Subject: Percent Impervious Cover Misused - CodeNEXT

By Joseph Reynolds

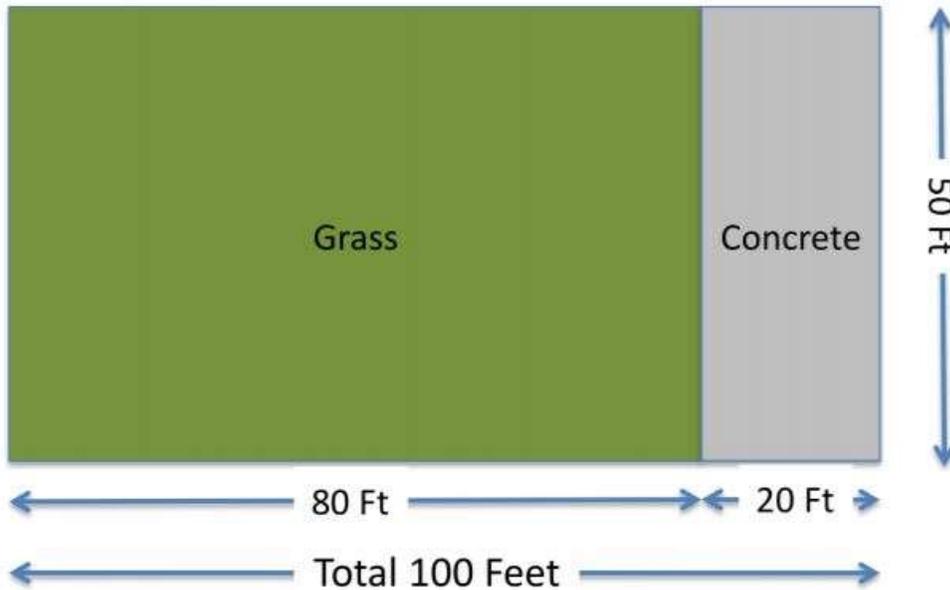
As I explained in previous documents, it is not the percentage of impervious cover that matters; it is the configuration, the shape and elevation of the surfaces, which is important. I’ll try to better illustrate that.

As I previously explained, because of the turbulence generated by water flowing fast past grass stems, the water is slowed as it flows across a lawn because energy is taken from the flow by the turbulence. Water is stored in the lawn until the rain stops. As a familiar example of the turbulence I mentioned wire whisks in the kitchen.

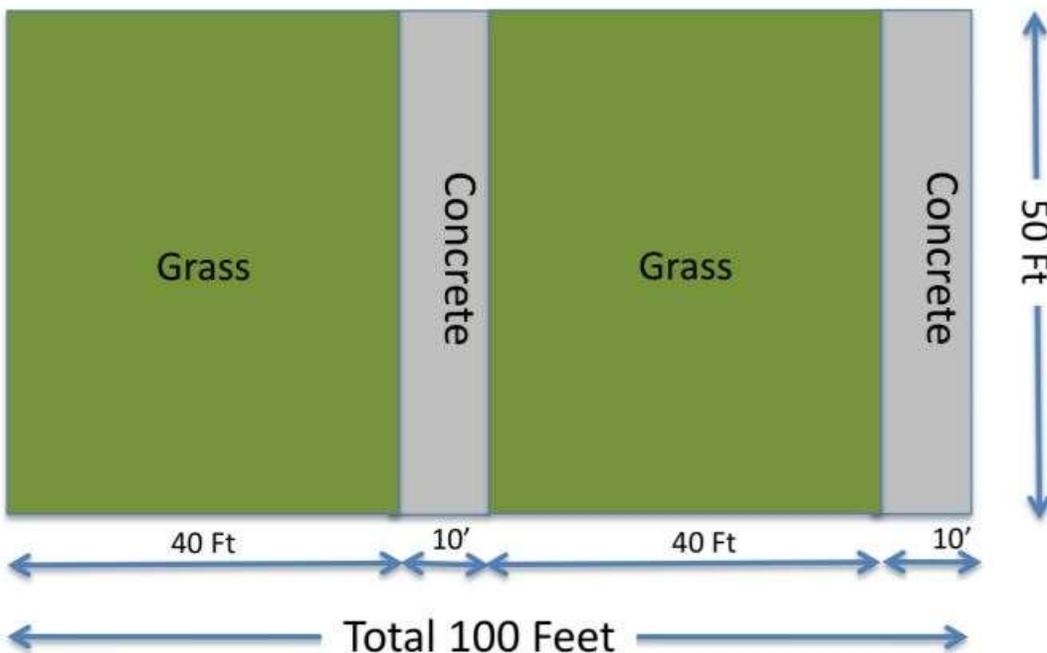
But, what if the lot was split? Just duplicated with the dimensions of the strips half as wide.

We still have just 20% concrete. The percentage of impervious cover hasn't changed. But, starting in the middle of the grass area the distances have changed. Now the water can get to concrete by flowing only 20ft to the driveway. Less distance to travel, less time to concrete, faster to the creek.

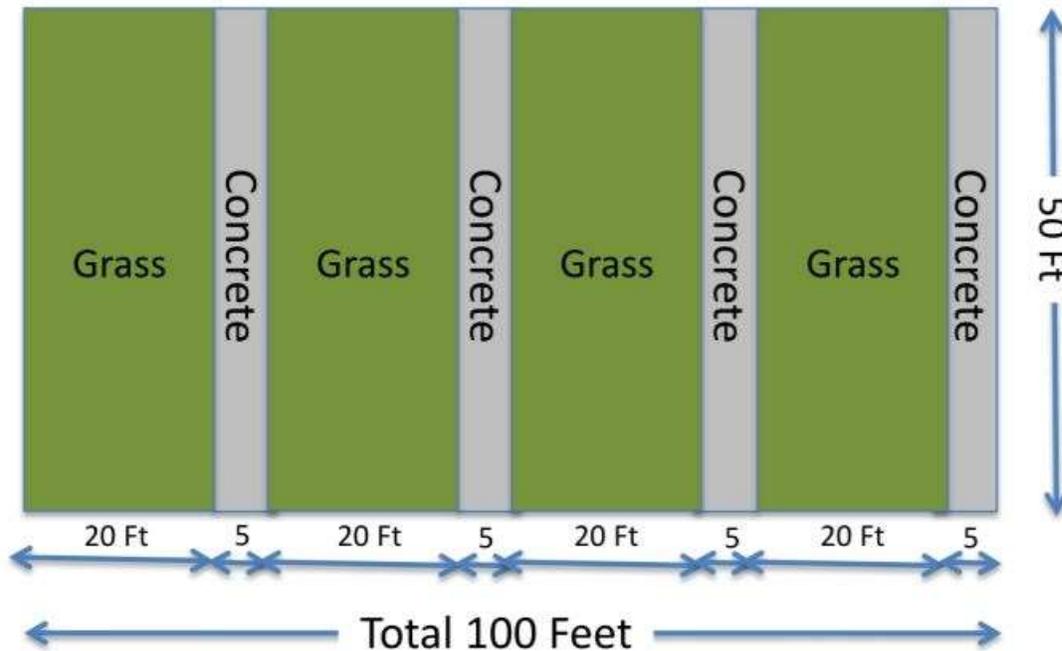
Now we're into townhouse conditions. Each sub-lot is 25ft wide, with a 5ft paved strip to drag the garbage to the street.

The rain falling into the middle of the grass must now only flow 10ft to get to a fast track to the creek. At each stage in the example the time to start filling the storm drains drops by a factor of two. There's the same amount of grass and concrete. The water flows at the same rate in the lawn; the grass effect is the same, but the time is half. The percent Impervious Cover hasn't changed. The geometry has changed. CodeNext encourages these types of small lots and does nothing to manage the holding time of the yards.

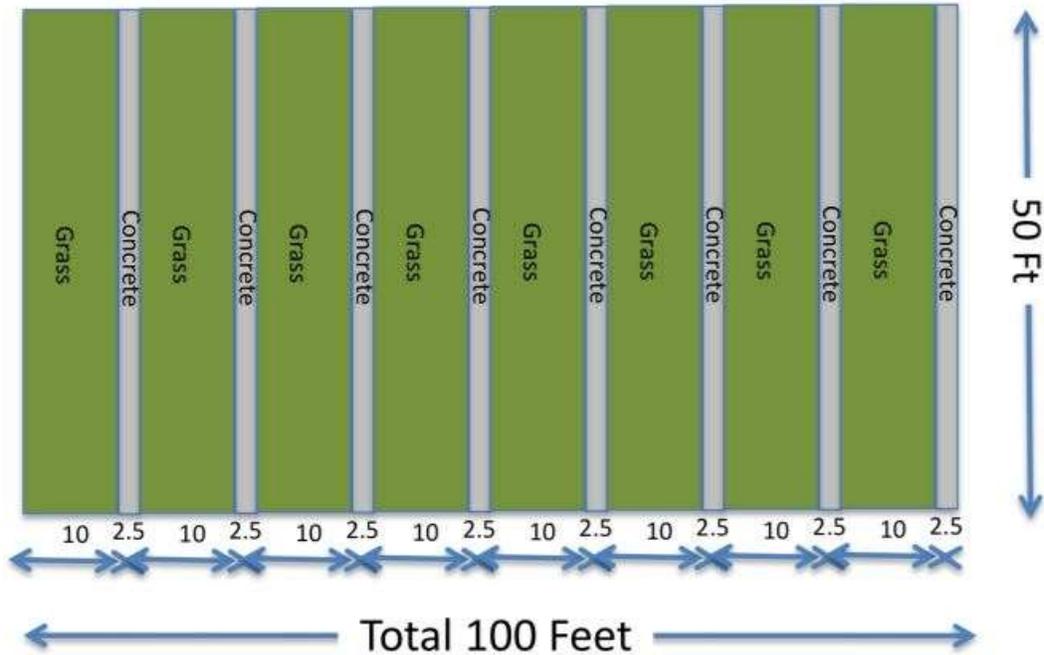
Now we have something like a bungalow. And, some grass with a sidewalk. Now the rain must only flow 5ft to get to a drain. The percentages aren't changed by making the lot shallower, say a 15ft instead of a 50ft or 25ft setback. That leaves almost no retention volume, and the percentage impervious cover hasn't changed.

This is a major problem when you consider flooding. Get it fixed. Stop the "handwave".
